# Access Compliance Report

## Public Rights-of-Way

Intersection ID: 12257	Main Street: W_3RD_ST	Cross Street: S_POPLAR_ST	Location: S
ADA ID: 0D19595A1F97	Ramp Type: Perp	Initial Pass/Fail: Fail	Overall Compliance: No
		Severity Score: 12.5

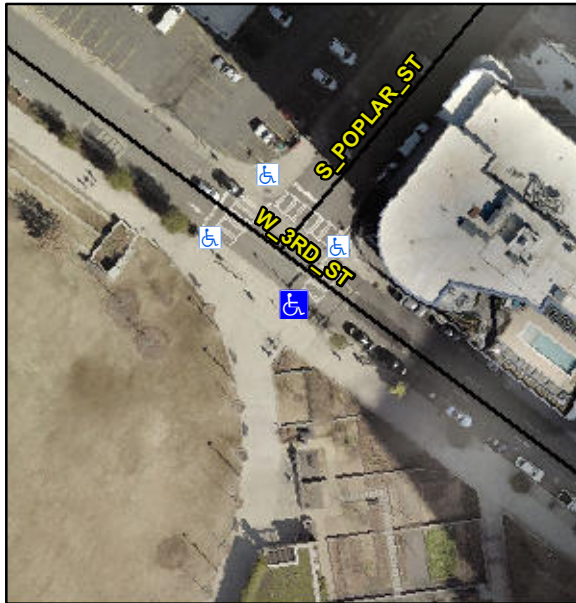
**Not Found, R304.2.2**

Compliance	Description	Data	Compliance	Description	Data
N/A	Ramp Length (in)	94.0	No	Ramp Slope (%)	9.7
Yes	Ramp Width (in)	53.0	Yes	Ramp XSlope (%)	0.2
N/A	Flare Type LT	N/A	N/A	Flare Type RT	N/A
N/A	Flare Slope LT (%)	N/A	N/A	Flare Slope RT (%)	N/A
N/A	Flare Traversable LT?	N/A	N/A	Flare Traversable RT?	N/A
N/A	Landing Length (in)	N/A	N/A	DWS Provided?	N/A
N/A	Landing Width (in)	N/A	N/A	DWS Contrast?	N/A
N/A	Landing Slope (%)	N/A	N/A	DWS Length (in)	N/A
N/A	Landing X Slope (%)	N/A	N/A	DWS Full Width?	N/A
N/A	Landing Curb? (Y/N)	N/A	N/A	DWS Offset (in)	N/A
N/A	Shared Landing?	N/A			
N/A	Gutter Ponding?	N/A	N/A	Gutter Slope (%)	N/A
N/A	Gutter Lip Ht (in)	N/A	N/A	Gutter X Slope (%)	N/A
N/A	Painted X Walk1?	Yes	N/A	Painted X Walk2?	N/A
	X Walk 1 Direction	To NE		X Walk 2 Direction	N/A
N/A	X Walk 1 Width (in)	123.0	N/A	X Walk 2 Width (in)	N/A
	X Walk 1 Slope (%)	1.4		X Walk 2 Slope (%)	N/A
	X Walk 1 X Slope (%)	3.5		X Walk 2 X Slope (%)	N/A

**Remove & Replace Entire Ramp.**
